10 CFR 50.46c Proposed Rule and Associated Draft Regulatory Guides Westinghouse Electric Power Company Recommendations

David Mitchell, Fellow Engineer
Rockville, MD
June 24, 2014

10 CFR 50.46c Proposed Rule and Draft Regulatory Guide DG-1261 Westinghouse Electric Power Company Recommendations

Issues Observed with DG-1261 breakaway testing.

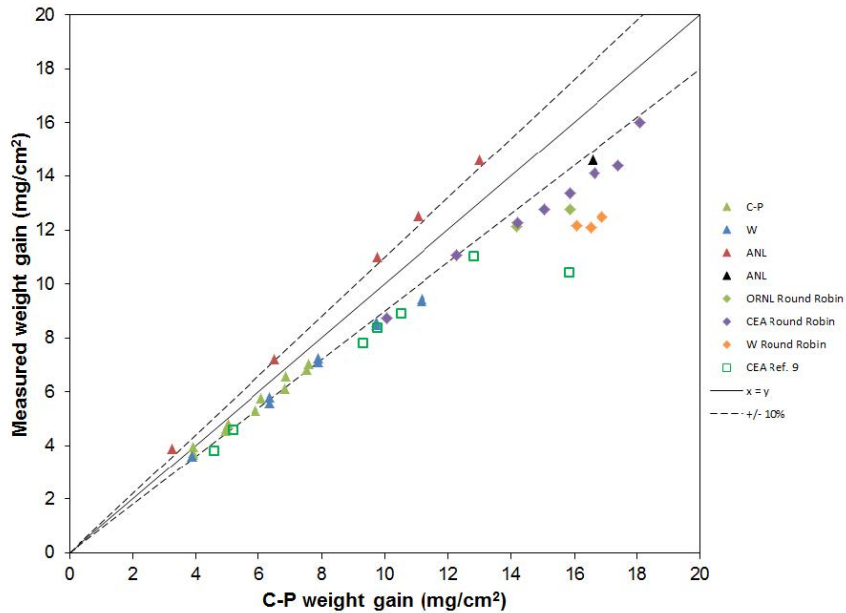
- Proposed breakaway corrosion testing and reporting is a disproportionate requirement to underlying phenomenon and the testing protocol is overly specific.
- Many cladding alloys including Zircaloy-4 and ZIRLO cladding do not follow $\pm 10\%$ of CP at 1,000°C at 2,000 sec and will not conform to DG-1261 assumptions.
- Doing breakaway in the range above 1,000°C can result in exceeding the ECR limit prior to the onset of breakaway.

- Testing to determine the minimum time to breakaway in the temperature range above 1,000°C should not extend beyond the time where the weight gain exceeds the allowable ECR (18%).
- The tolerance on the scratch depth should be removed. A process which replicates scratching cannot meet the tolerance proposed.
- The requirement to demonstrate that weight gain is within $\pm 10\%$ of the CP prediction at 1,000 °C should be removed. Normal thermocouple calibration procedures should be sufficient.
- The requirement to use Grade A feed water with < 45 ppb O content should be changed to only require Grade A water.
